Notice of Preparation (NOP) and Responses to the NOP

SUBJECT: Notice of Preparation: Draft Environmental Impact Report for the Las Camas Solar Project
(Conditional Use Permit No. CUP 20-011; General Plan Amendment No. 20-001; and Zone
Change Amendment No. ZC 21-002)

Notice of Preparation Las Camas Solar Project

Figure 2
Proposed Site Plan
 Las Camas Solar Project - Merced County, California

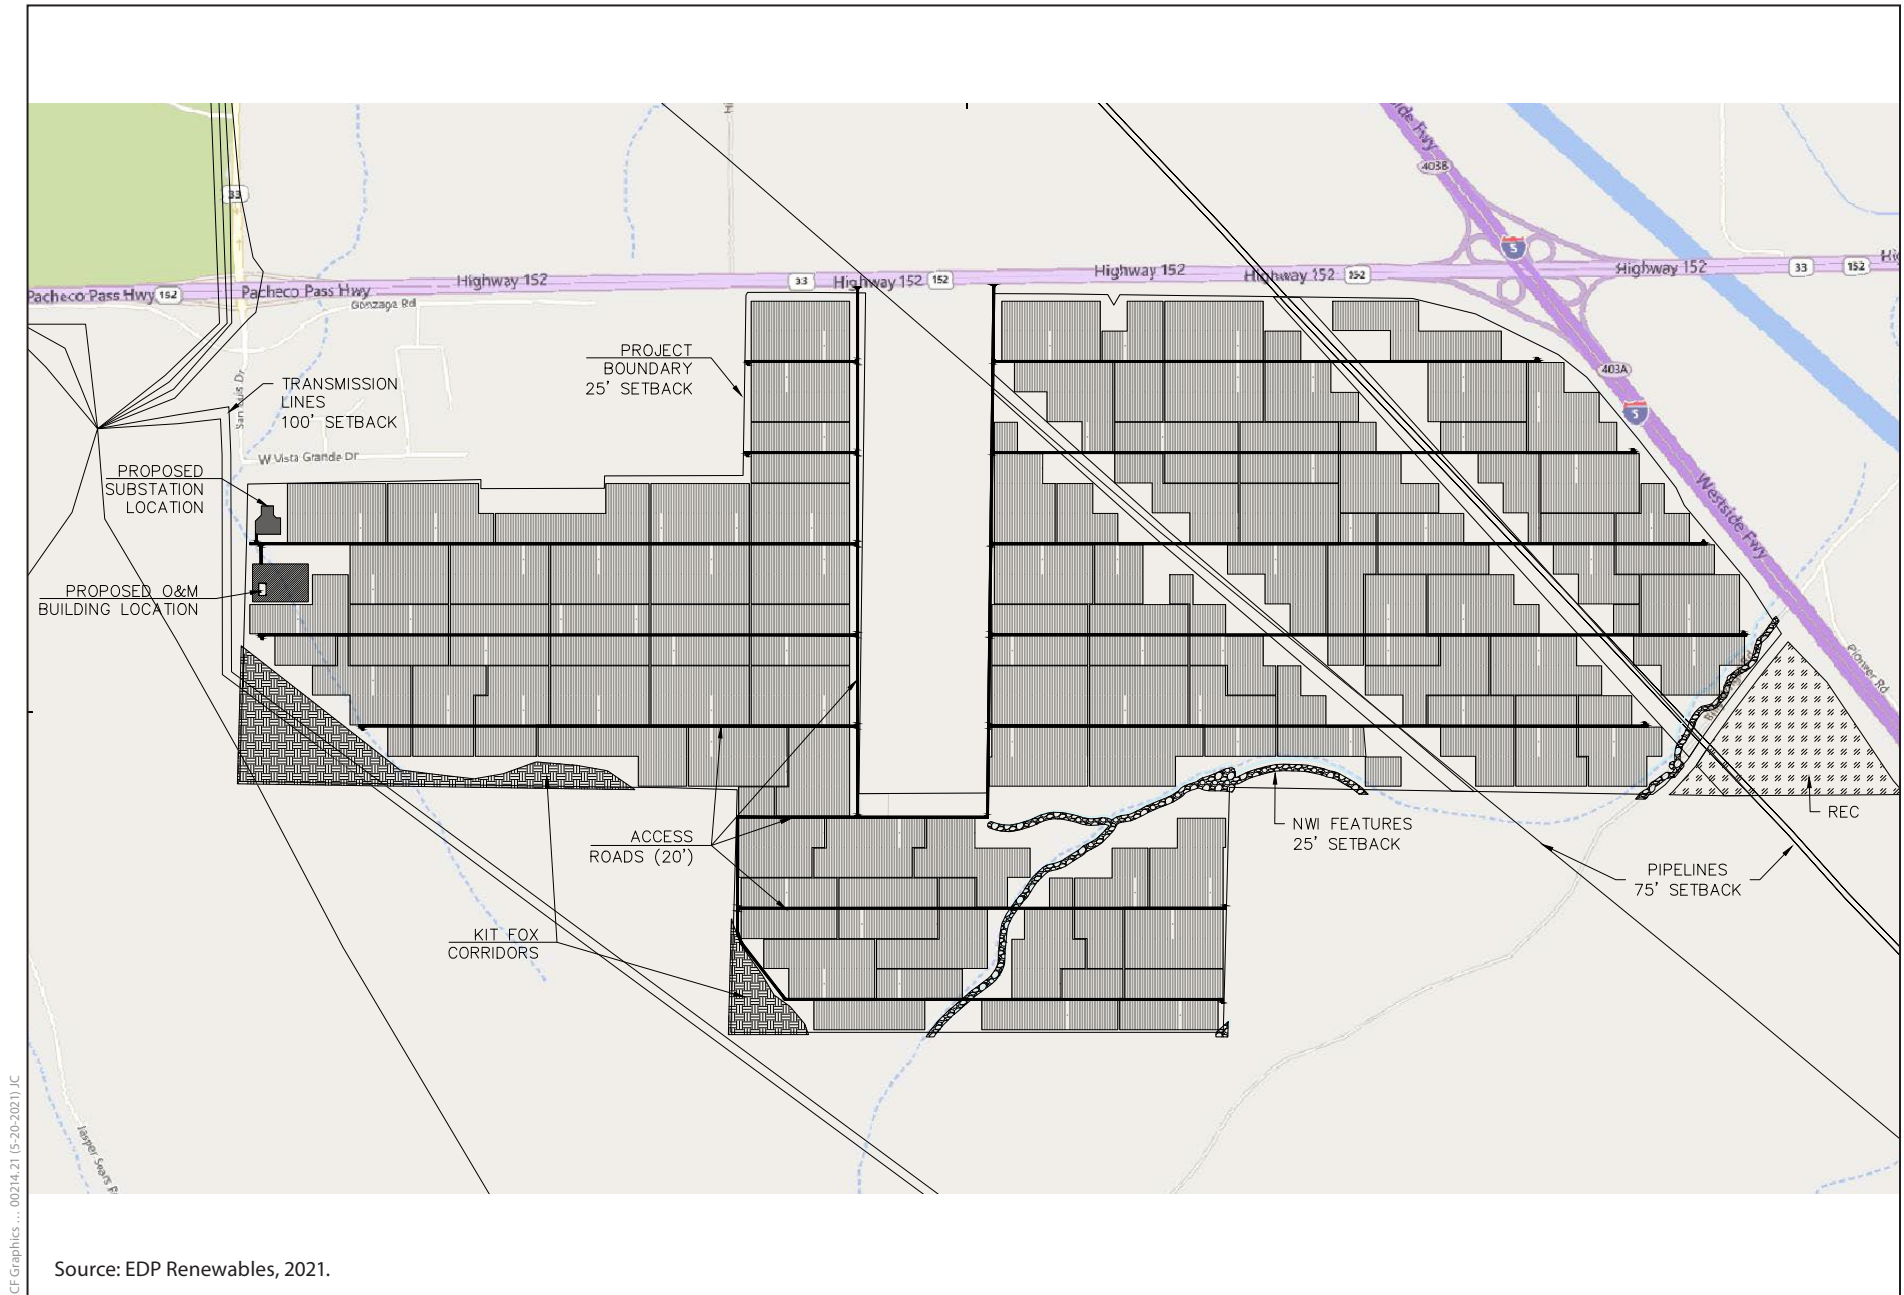
- Steve Stadler, District Engineer, San Luis Water District
 - Will be sending a formal letter within the response period
 - Indicated there are facilities on-site that are not identified in the site plan and may require accommodations/revisions to plan
 - Indicated the District has its own process to determine feasibility for connection for District's M&I water (water supply plan)

2. Figure 2, Proposed Site Plan, included in the NOP does not show SLWD pipelines, water delivery turnouts, electrical cables, telemetry cables, and other SLWD facilities and their corresponding easements that cross the project site. These facilities should be shown on the map. Access and avoidance of these facilities should be incorporated into the project design (as was done with the two underground gas pipelines and their corresponding easements). Because this may significantly alter the design of the project, a revised site plan should be prepared prior to an evaluation of the environmental impacts.
